N7000A-01

Modification Recommended Service Note

N7000A InfiniiMax III+ Series 8 GHz Probe Amplifier
Serial Numbers: ALL

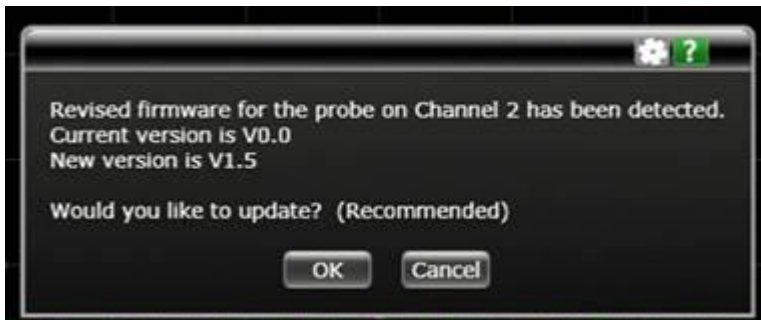
1. Ask the customer if he/she has seen the following message when plugging his/her probe onto an oscilloscope:

2. Regardless of the customer's answer to the question, plug the customer's probe onto a Service Center scope with software version 06.20.00701 or later.
3. If the Customer said No in step 1 or was unsure: tell the customer that Keysight recommends downloading latest scope software version—Version 06.20.00701 or later. Continue with standard procedure.
4. If the Customer said Yes, the probe appears to function normally on the scope, and it passes calibration, the probe has been fixed. Send the original probe back to the customer, and tell the customer that Keysight recommends an upgrade to oscilloscope software—Version 06.20.00701 or later to prevent this issue from re-occurring to their probe.
